Product Change Notice  
PCN Tracking Number: TMJ-PP-0733

2. Description of change

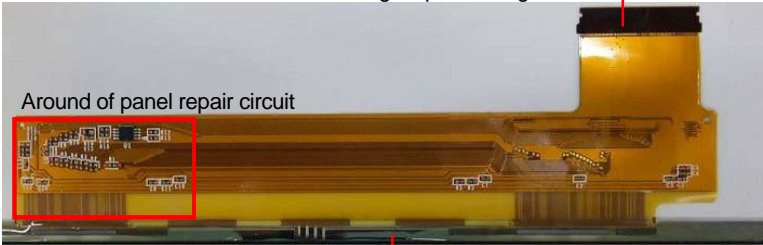
The panel repair circuit will be removed, because the quality of LCD panel becomes higher along with production site change and the necessity of the panel repair circuit becomes lower. The panel repair circuit is not used in usual production and used only when the line defect occurred. Therefore, there are no optical or electrical specifications change and no changes in product reliability. And there will be no influence on UL approval and RoHS compliance. The details are shown in following table.

Item	Description				
<p>FPC (Flexible printed circuit)</p> <p>Panel repair circuit</p>	<p>For the removal of panel repair circuit, a part of assembled parts on FPC will be removed. Please refer to following pictures.</p> <p>Note: FPC, which is an internal part of product, connects LCD panel and signal processing board and inputs the signal to LCD panel.</p> <p>Over view of FPC</p>  <p>To Signal processing board ↑</p> <p>↓ To LCD panel</p> <p>Around of panel repair circuit</p> <p>Around of panel repair circuit</p> <table border="0"> <tr> <td data-bbox="643 1144 732 1207">Mounted R17, R18</td> <td data-bbox="797 1129 954 1192">Mounted U1, C15, R12~16</td> <td data-bbox="1068 1157 1182 1220">Not mounted R17, R18</td> <td data-bbox="1271 1129 1429 1192">Not mounted U1, C15, R12~16</td> </tr> </table>  <p>The shape of the FPC and electric wiring and will not be changed.</p>	Mounted R17, R18	Mounted U1, C15, R12~16	Not mounted R17, R18	Not mounted U1, C15, R12~16
Mounted R17, R18	Mounted U1, C15, R12~16	Not mounted R17, R18	Not mounted U1, C15, R12~16
